CANBY PLANNING COMMISSION

January 13, 1992 - 7:30 p.m.

**RE: Supplemental Staff Report
- North Pine Addition II (SUB 91-01)**

- STAFF REPORT -

Plan as Approved
in Final Order
1-17-91

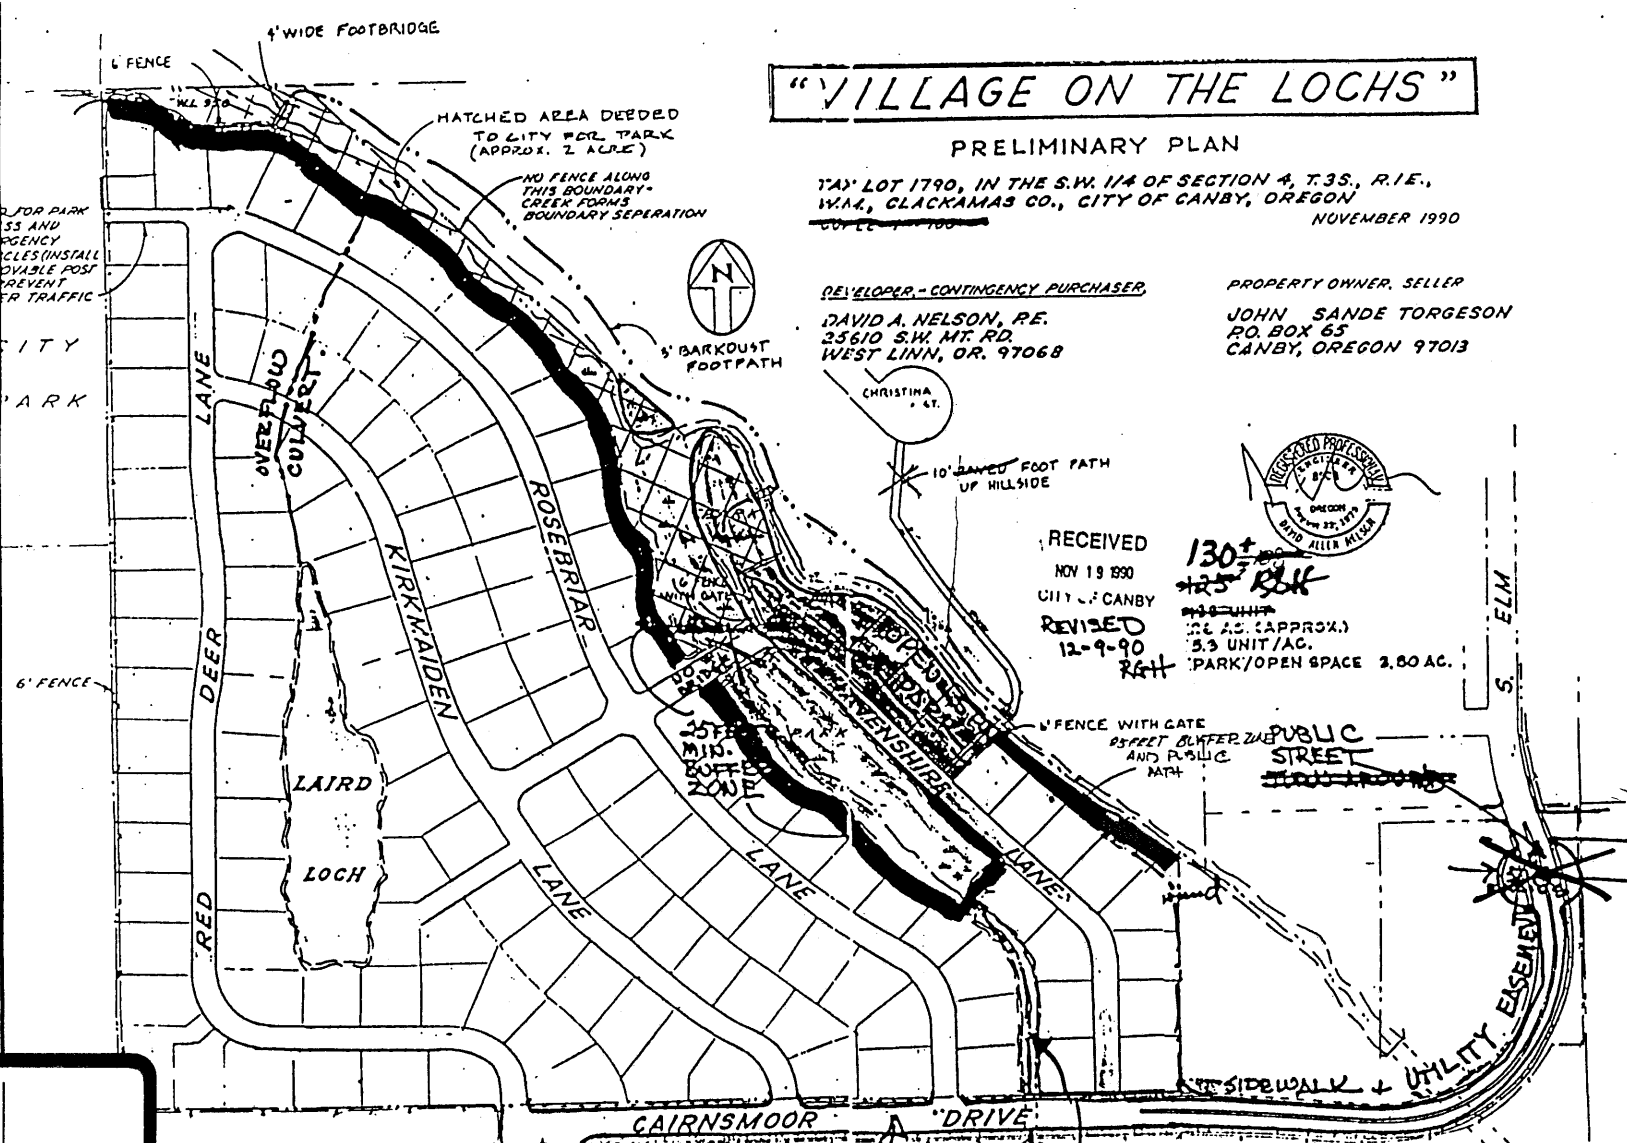
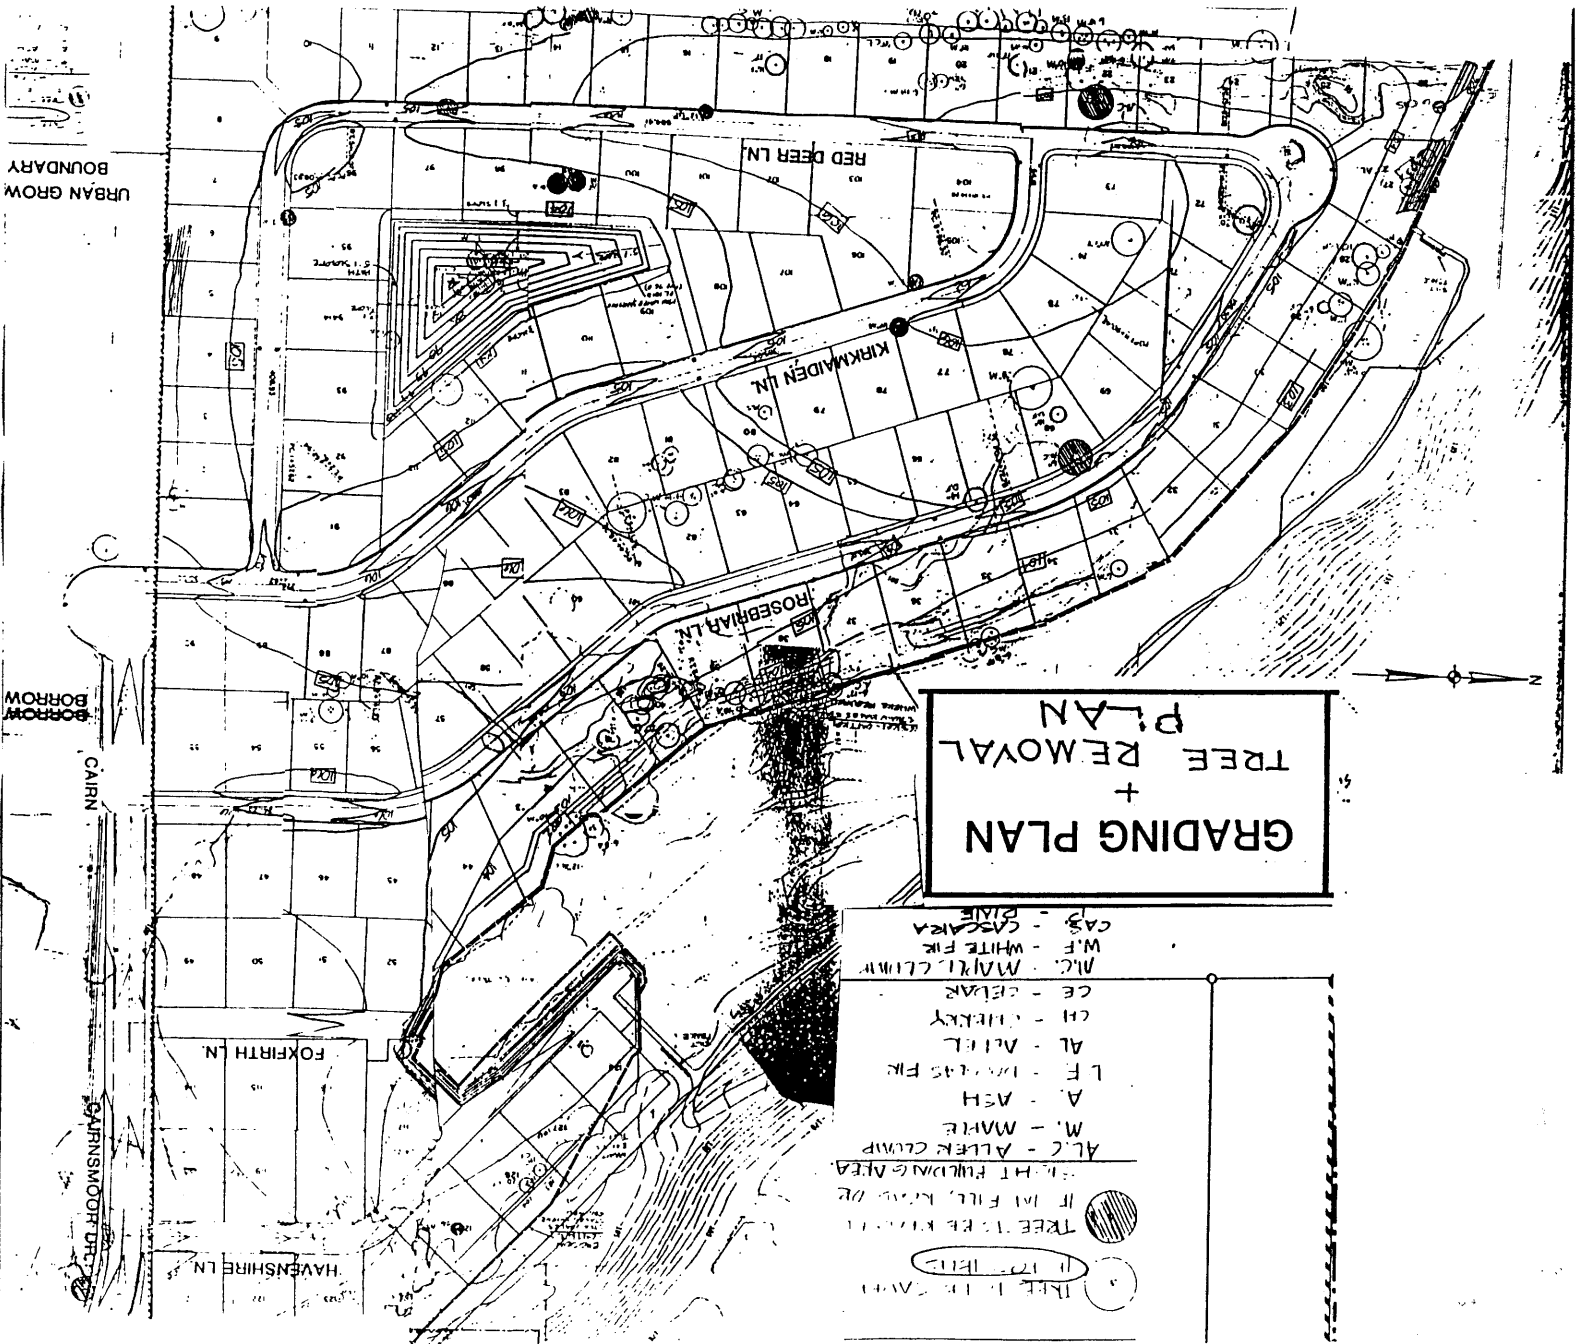
The proposed changes to the approval conditions do not appear to affect whether the site is suitable for a manufactured home park. The revision of the original site plan to eliminate the need for a vehicular bridge provides better protection of the wetlands and, therefore, bridge weight restrictions are not needed. Notice of flooding potential within the park operating rules, rather than through signs, appear to staff to be just as effective and less ominous. **Timing** of grading permit does not affect site suitability.
